Independent Design Review

For Central Coast Council

DA – 59571/2020

89 & 91 Karalta Rd Erina

L1/GF
SCALE 1:200 @ A1

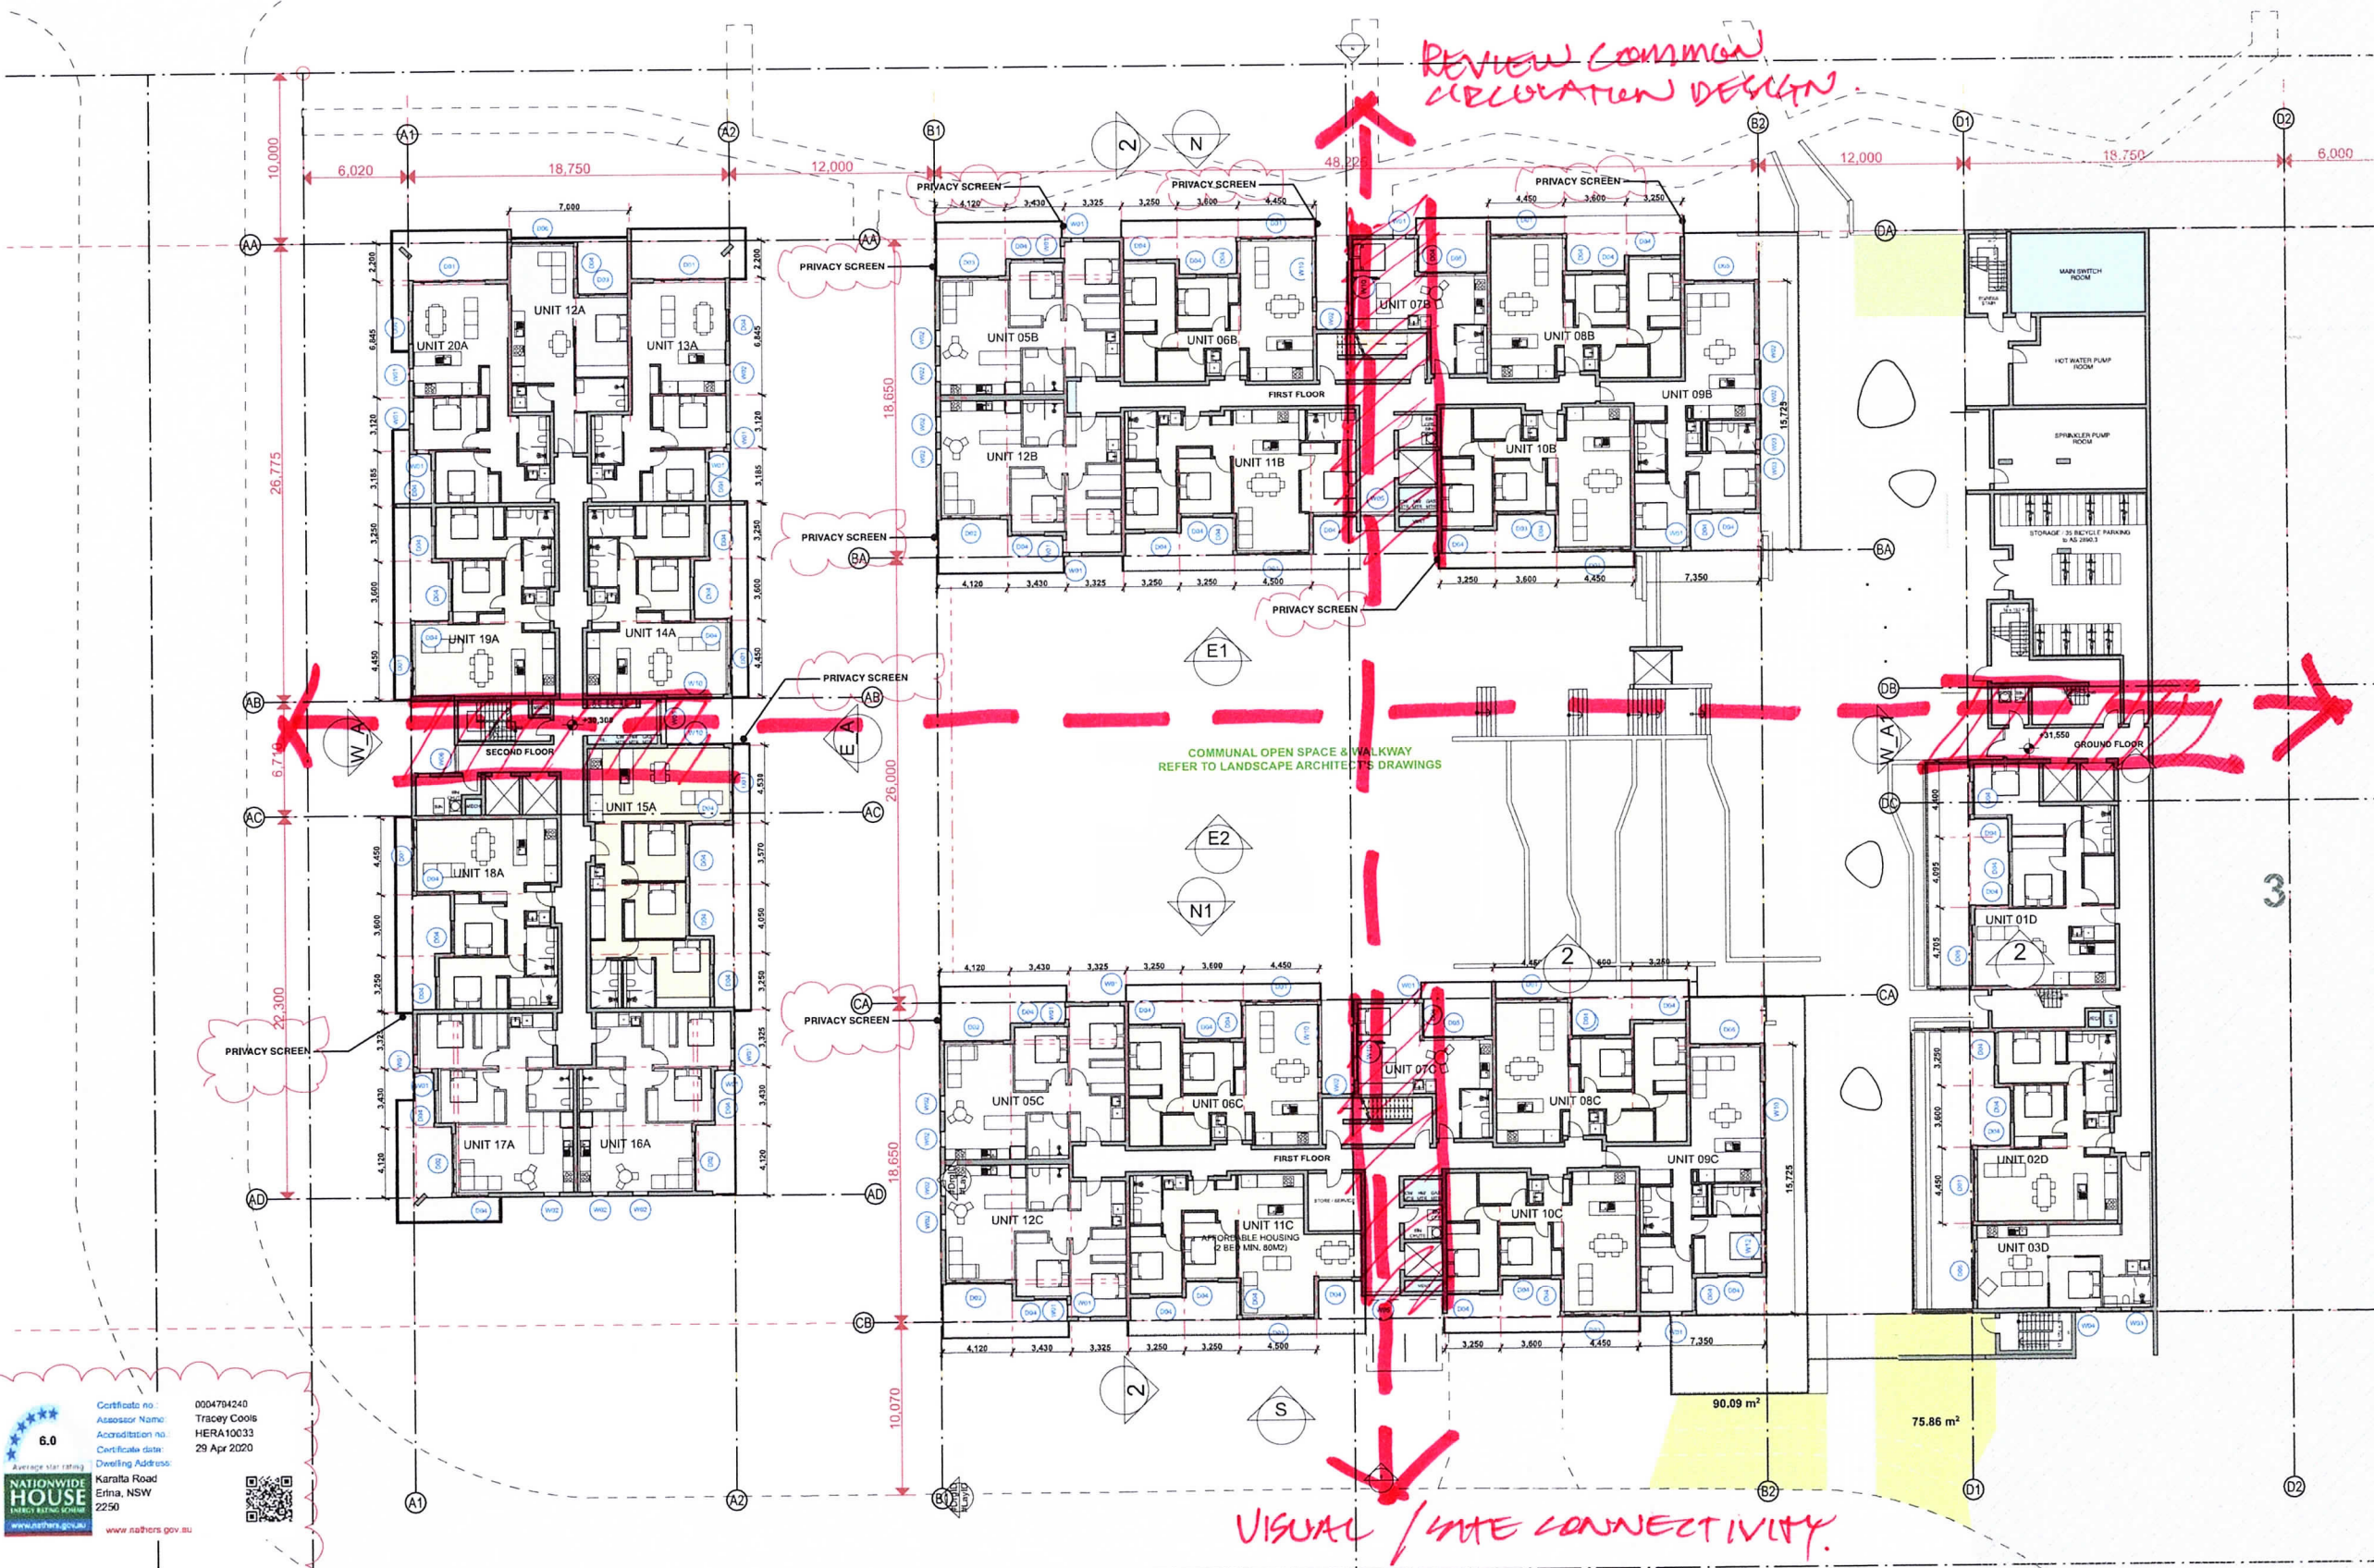
REVIEW COMMON CIRCULATION DESIGN.

COMMUNAL OPEN SPACE & WALKWAY REFER TO LANDSCAPE ARCHITECT'S DRAWINGS

VISUAL / SITE CONNECTIVITY.

PERMEABILITY OF BUILDING COMMON SPACE (BETTER AMENITY FOR INTERNALISE CIRCULATION)

drawing title
Elevations
South longitudinal elevation
& North longitudinal
elevation

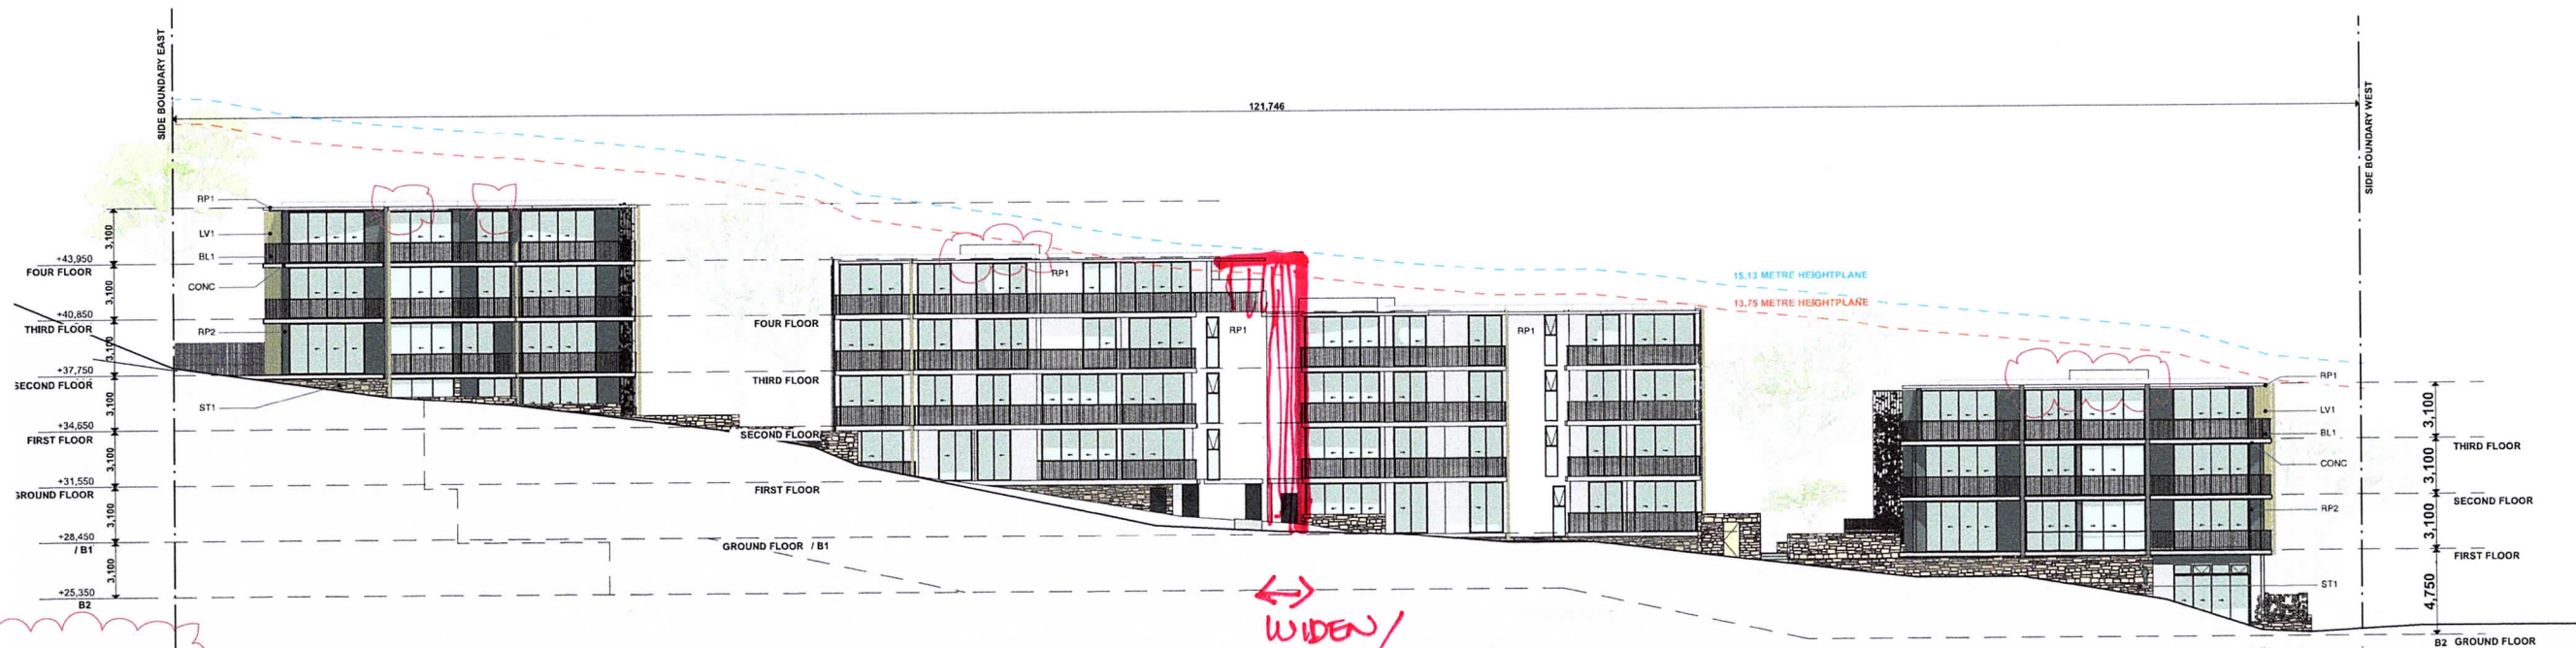
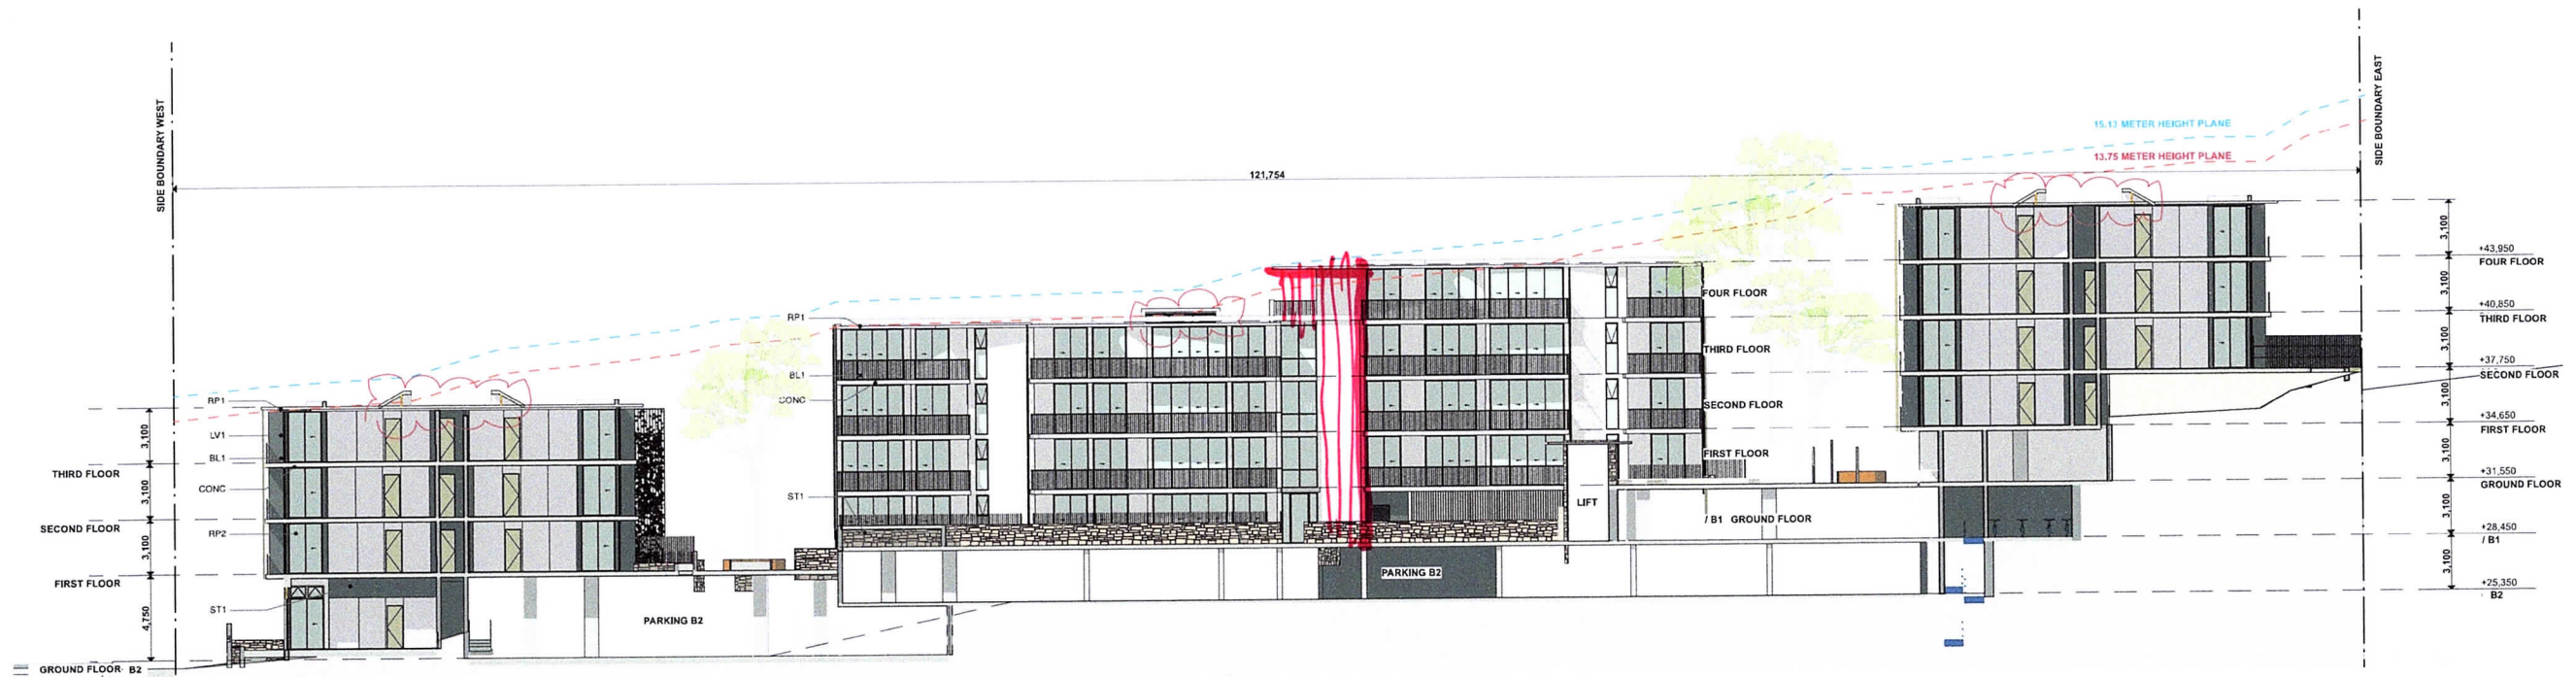
WIDEN/
MAKE PERMEABLE.
CONNECTION THROUGH
BUILDING.

Elevations
Building B south elevations
& Building C north
elevations

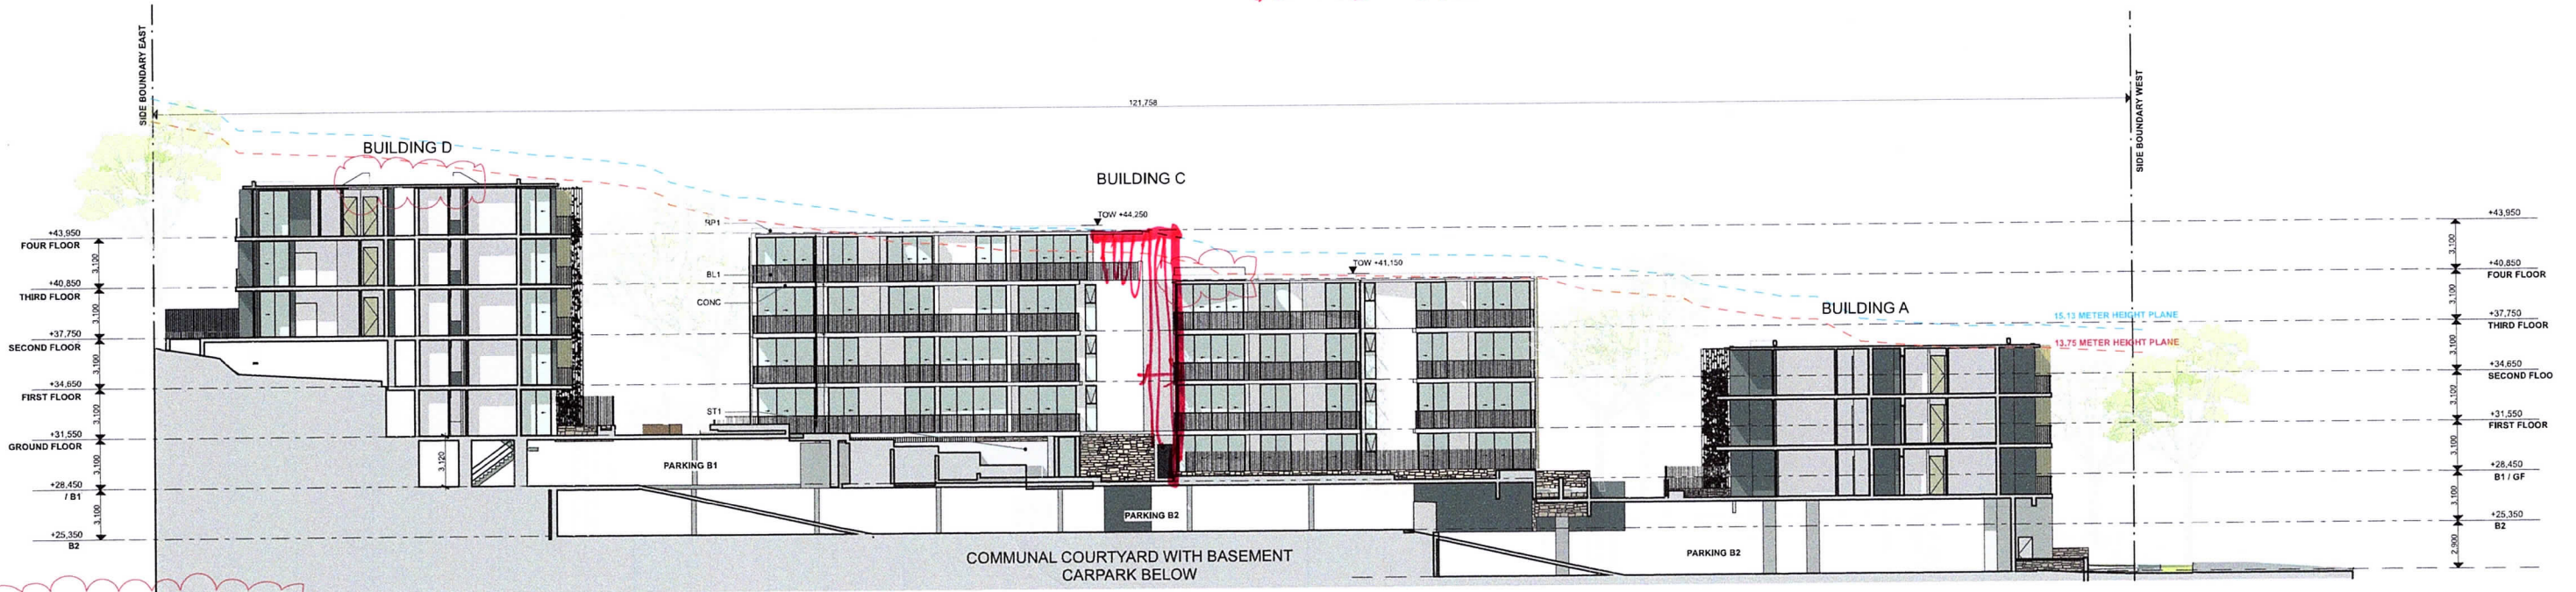
ACCENTUATE.
COMMON CIRCULATION.
